LEHIGH RIVER BASIN,
POHOPOCO CREEK, PENNSYLVANIA .

BELTZVILLE LAKE.

CONDITION REPORT. DAM, OUTLET WORKS & SPILLWAY PERIODIC INSPECTION REPORT, NO. 1,

JULY 1970.

Photo No. 6 Potential undermining of guard
rail downstream of outlet works.

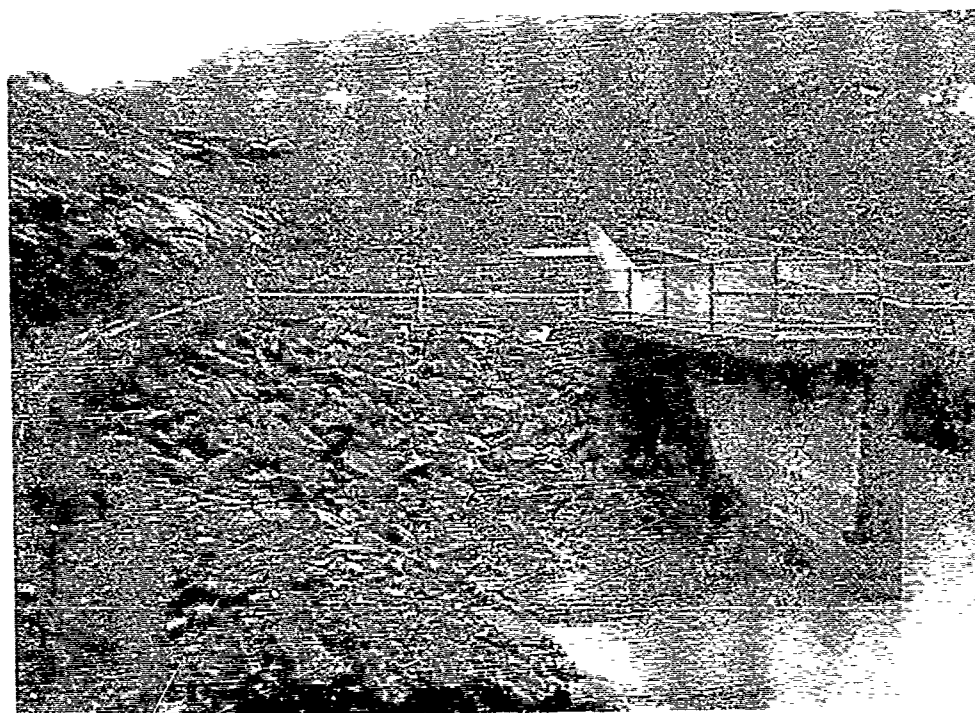
(3) Outlet works area: Photographs 6, 7 and 8 show areas of possible future erosion problems and were taken for comparison purposes only. Captions identify the area.
